**Product Change Notification / MFOL-06JTCQ469**

CCB 6300 Initial Notice: Qualification of ASEK as an additional assembly site for selected MCP356xx and MCP346xx device families available in 20L UQFN (3x3x0.55mm) package.

**CCB 6300**  
**Pre and Post Change Summary**  
**PCN #: MFOL-06JTCQ469**

# Pre and Post Change – Lead Frame Comparison

## LPI

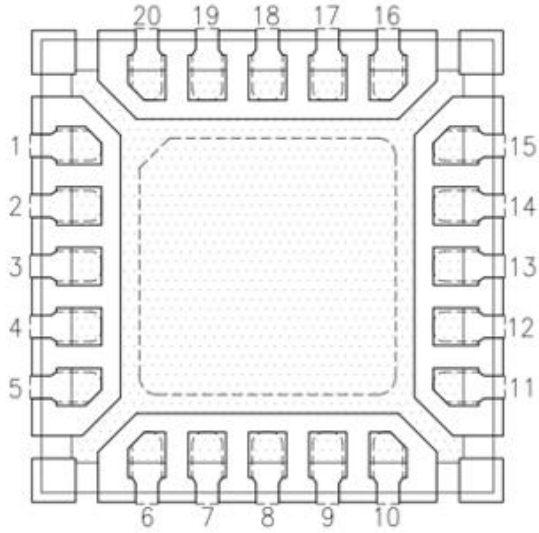
Lead Frame Material	C7025
Lead Frame Treatment	None
Lead Frame Paddle Size	77x77 mils
DAP Surface Prep	Spot

## ASEK

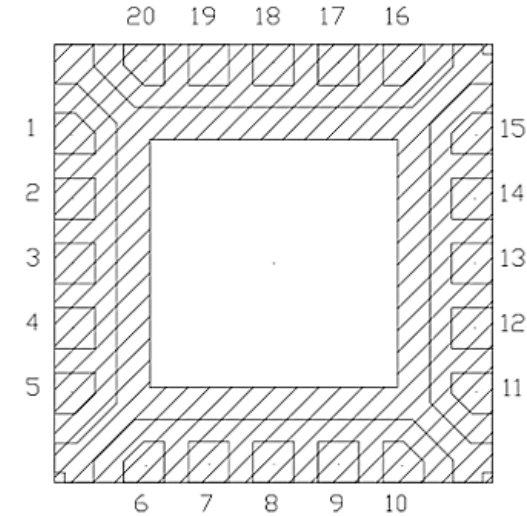
Lead Frame Material	C7025
Lead Frame Treatment	Roughened
Lead Frame Paddle Size	76x76 mils
DAP Surface Prep	Double Ring Ag
